Access Compliance Report

Public Rights-of-Way

(Curb Ramps)

Intersection ID: N/A	Main Street: ARDREY_KELL_DR	Cross Street: BLAKENEY_PRESERVE_LN	Location: SE
ADA ID: 12D09AFEFC9C	Ramp Type: PerpDiag	Initial Pass/Fail: Fail	Overall Compliance: No
Codes/Mitigation Info/Possible Solution			Severity Score: 10
			Field Measurements/Component Compliance

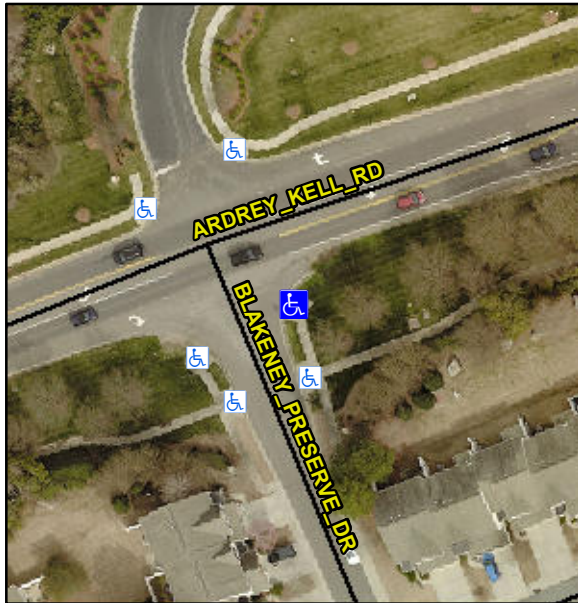
R304.5.1, R304.5.3

Compliance	Description	Data	Compliance	Description	Data
N/A	Ramp Length (in)	71.0	Yes	Ramp Slope (%)	5.1
No	Ramp Width (in)	43.0	No	Ramp XSlope (%)	4.9
N/A	Flare Type LT	N/A	N/A	Flare Type RT	N/A
N/A	Flare Slope LT (%)	N/A	N/A	Flare Slope RT (%)	N/A
N/A	Flare Traversable LT?	N/A	N/A	Flare Traversable RT?	N/A
N/A	Landing Length (in)	N/A	N/A	DWS Provided?	N/A
N/A	Landing Width (in)	N/A	N/A	DWS Contrast?	N/A
N/A	Landing Slope (%)	N/A	N/A	DWS Length (in)	N/A
N/A	Landing X Slope (%)	N/A	N/A	DWS Full Width?	N/A
N/A	Landing Curb? (Y/N)	N/A	N/A	DWS Offset (in)	N/A
N/A	Shared Landing?	N/A			
N/A	Gutter Ponding?	N/A	N/A	Gutter Slope (%)	N/A
N/A	Gutter Lip Ht (in)	N/A	N/A	Gutter X Slope (%)	N/A
N/A	Painted X Walk1?	No	N/A	Painted X Walk2?	No
	X Walk 1 Direction	To N		X Walk 2 Direction	To W
N/A	X Walk 1 Width (in)	N/A	N/A	X Walk 2 Width (in)	N/A
	X Walk 1 Slope (%)	3.7		X Walk 2 Slope (%)	0.6
	X Walk 1 X Slope (%)	0.1		X Walk 2 X Slope (%)	4.3

N/A	Ramp inside XWalk1?	N/A	N/A	Ramp inside XWalk2?	N/A
	Road Slope (%)	2.3	N/A	Clear Space?	N/A
	Road X Slope (%)	4.2	N/A	Clear Space to XWalk (in)	N/A
N/A	Any Obstructions?	N/A	N/A	Storm Grate/Utility Hazard?	N/A
	Obstruction Type			Storm Grate/Utility Type	
		N/A			N/A
			Yes	Surface Condition? (G/P)	Good

Remove & Replace Curb Ramp With Two New Directional Ramps or Equivalent.
